Yuba Community College District

No. RFP 22-14

New Softball Field

ADDENDUM NO. 2

Sheet of
L1.1

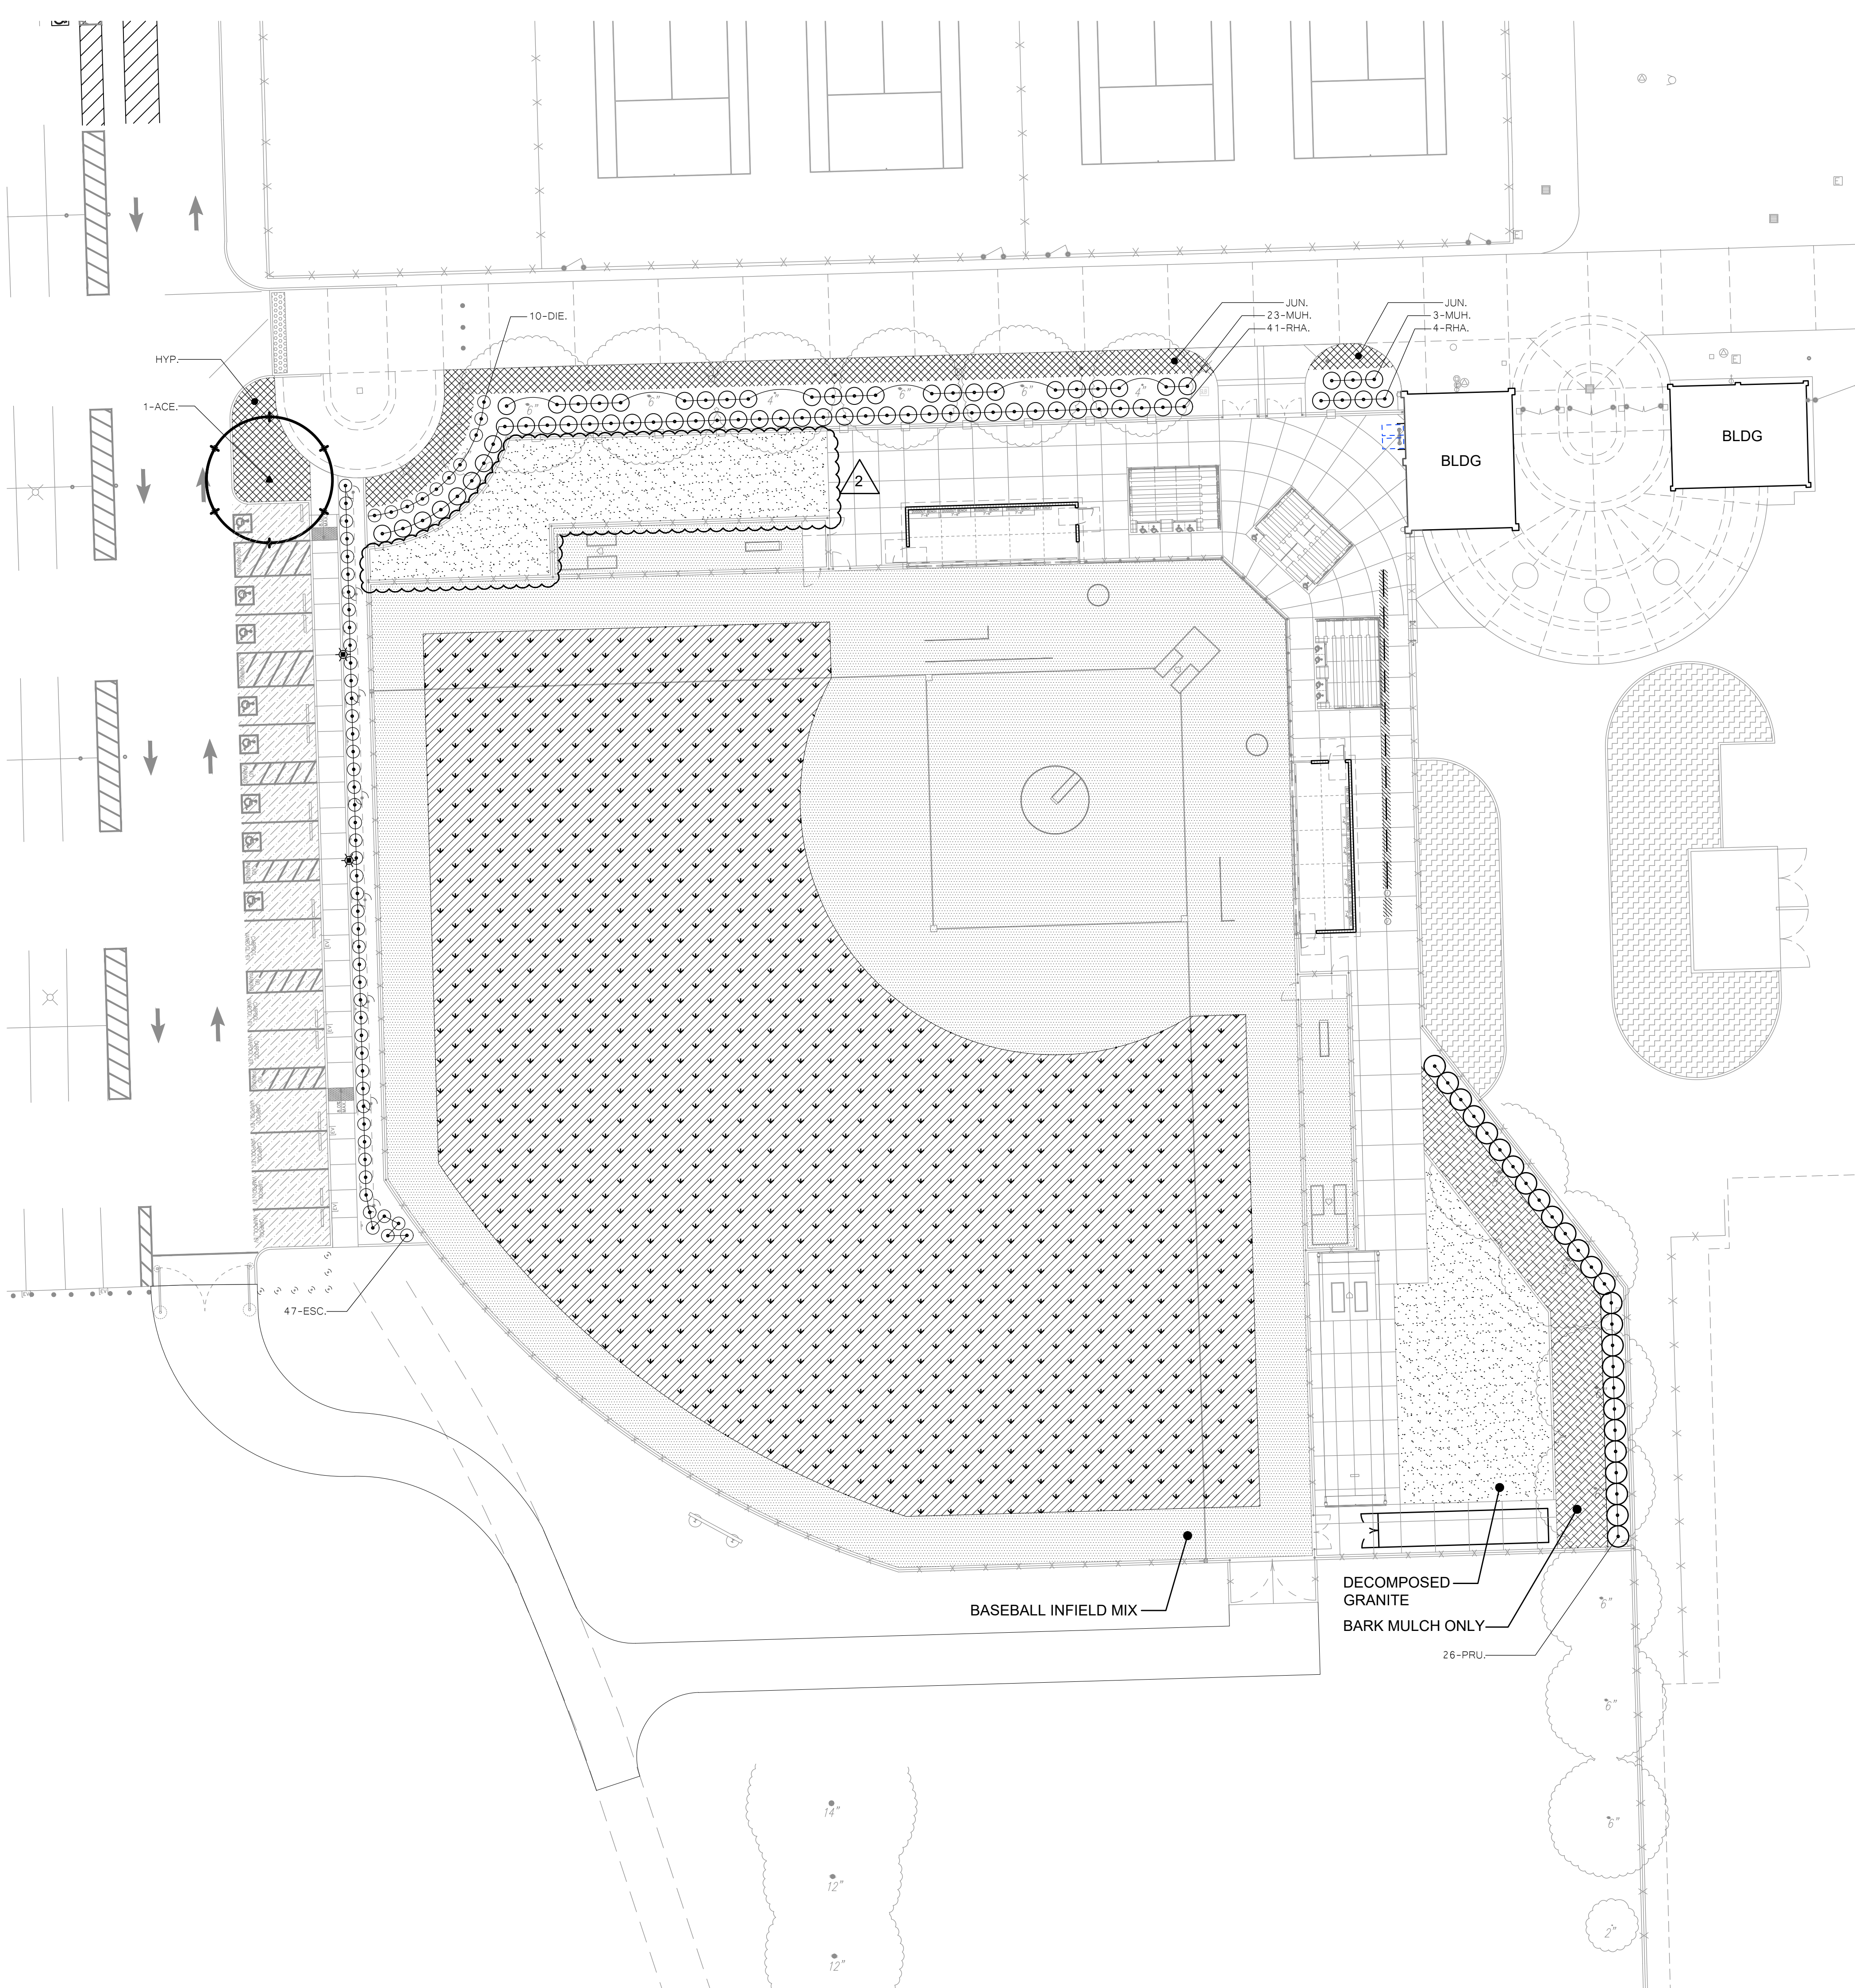
2.9 Refer to Drawing Sheet L1.1

- A. **REVISE** area north of northern bullpen to decomposed granite in lieu of planting and omit irrigation in area. **See attached 'Sheet L1.1'**

Client Project Number: _____ Client Proj. # _____
Scale: _____ Sheet _____
Drawn By: PL
Checked By: PL
Issue Date: 12/16/22
Revit Version: 2023
L2.1
Sheet of _____

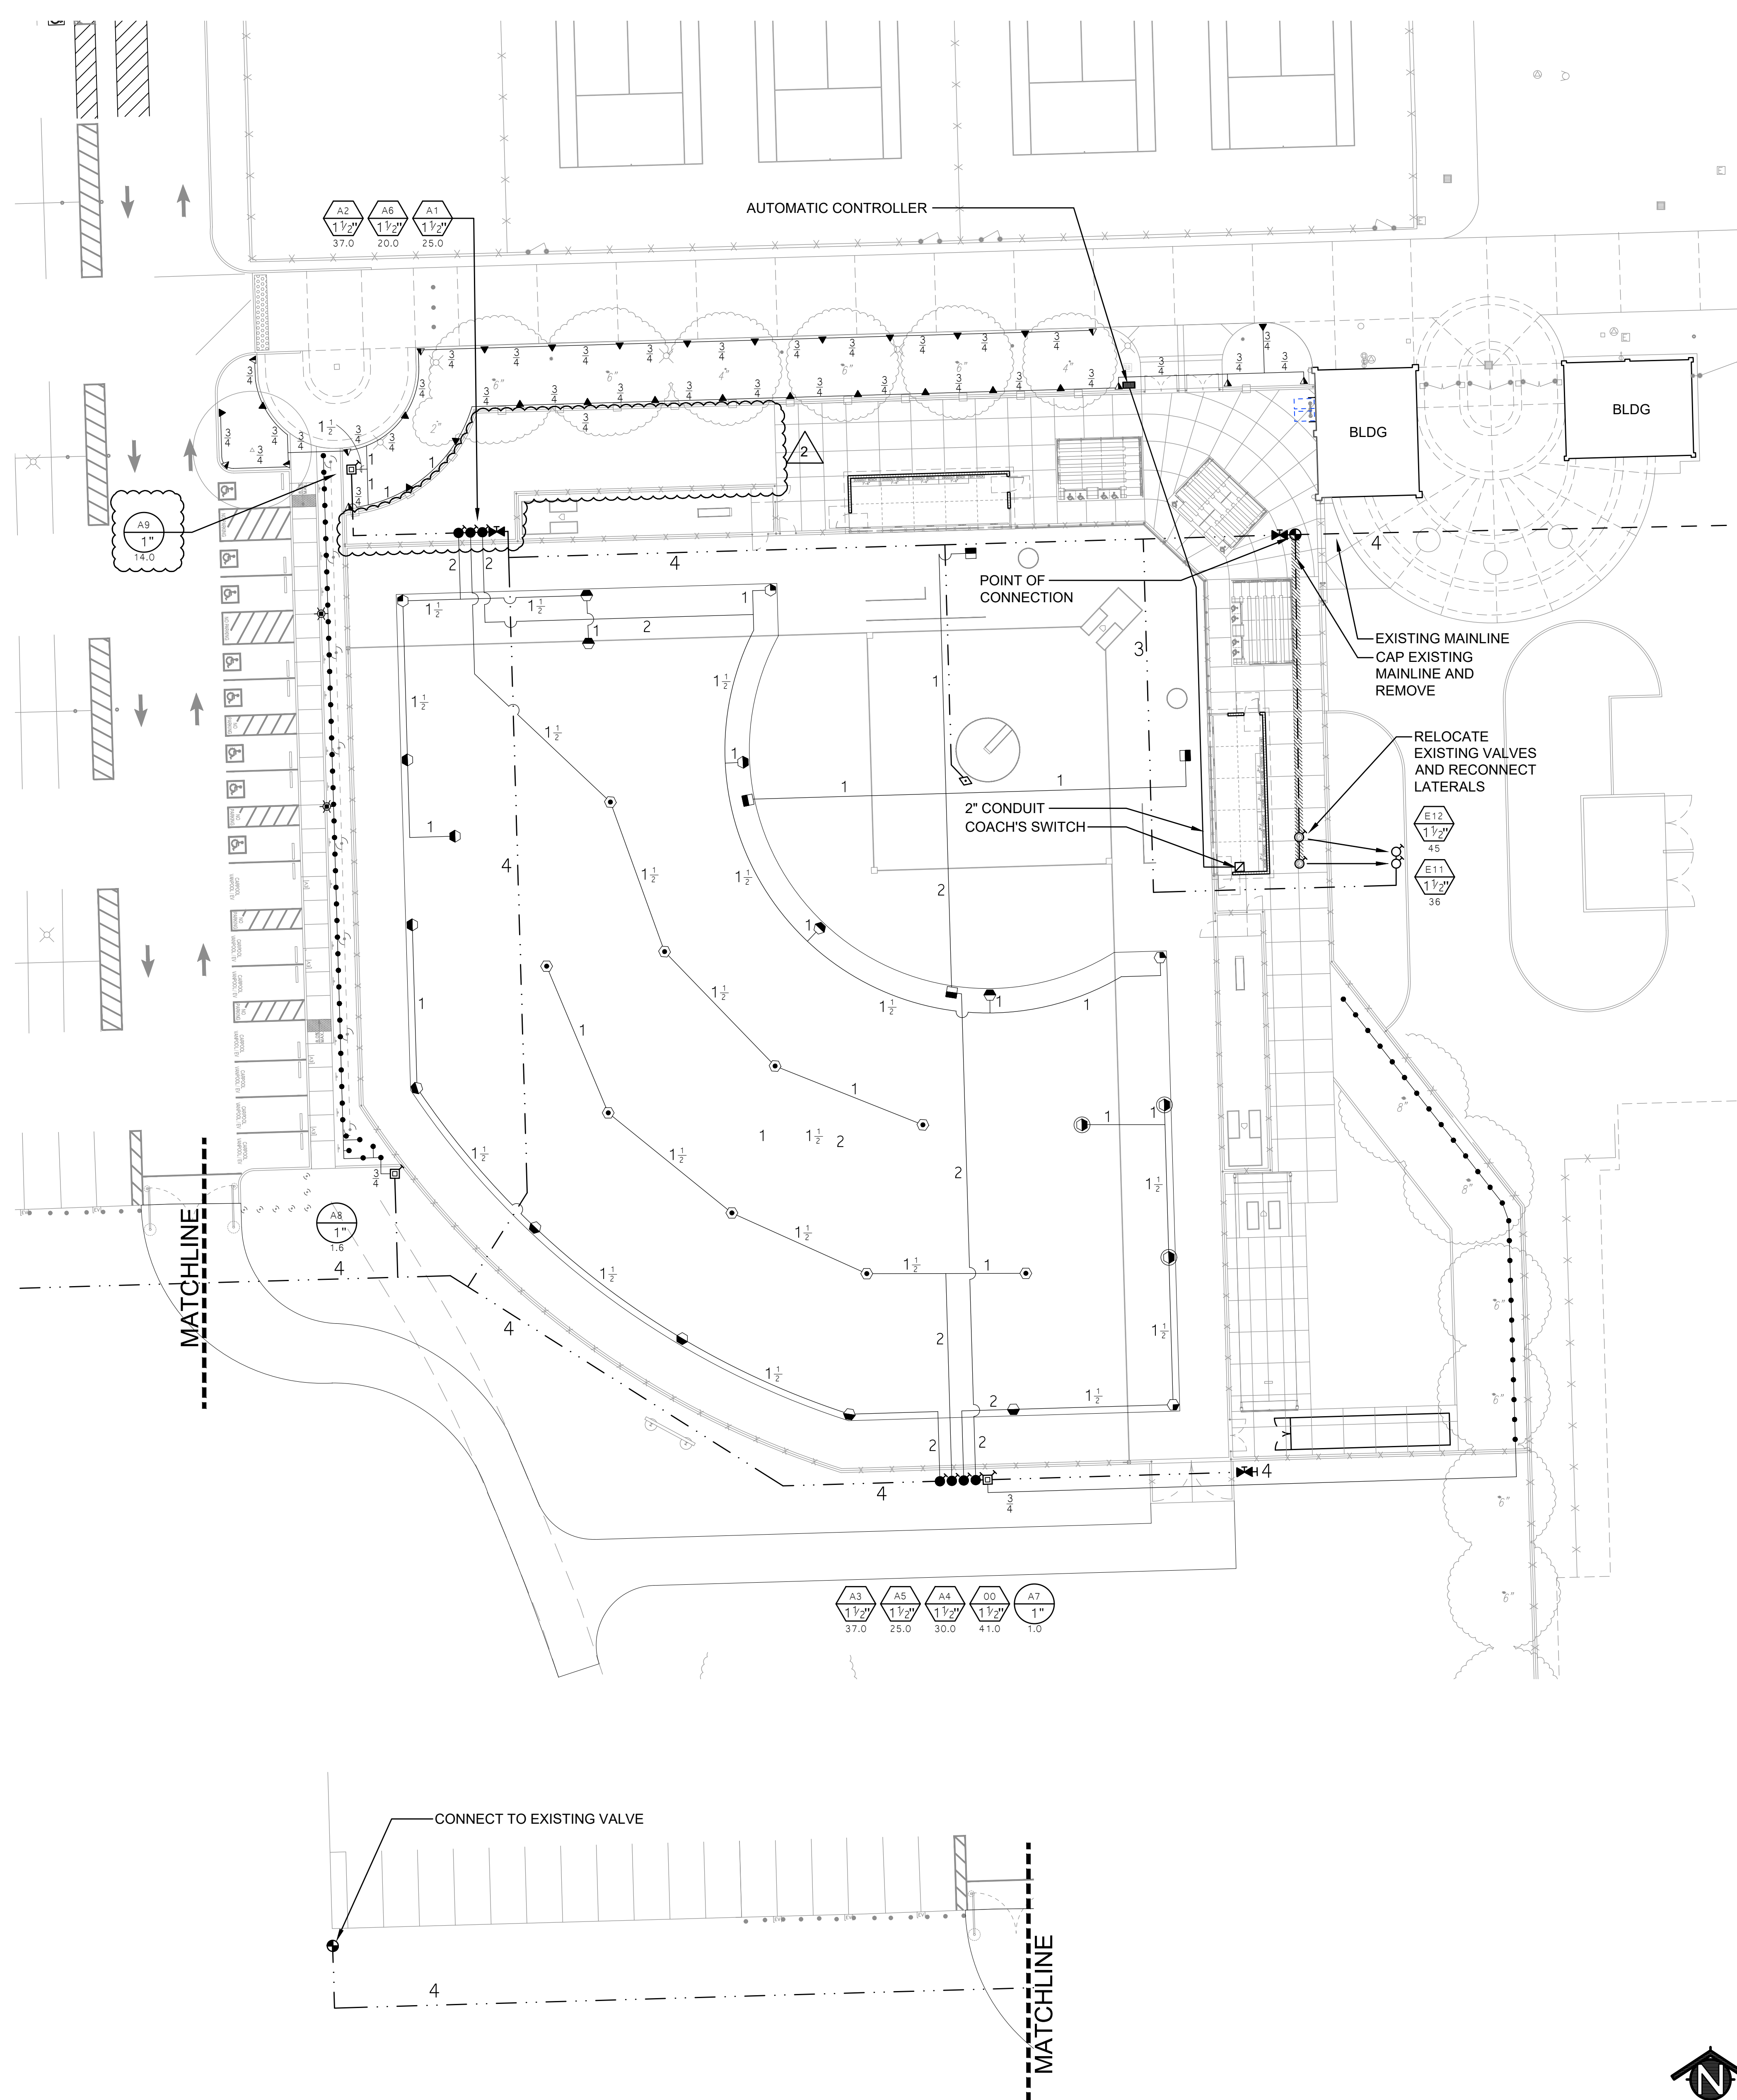
2.10 Refer to Drawing Sheet L2.1

- A. **REVISE** area north of northern bullpen to decomposed granite in lieu of planting and omit irrigation in area. **See attached 'Sheet L2.1'**
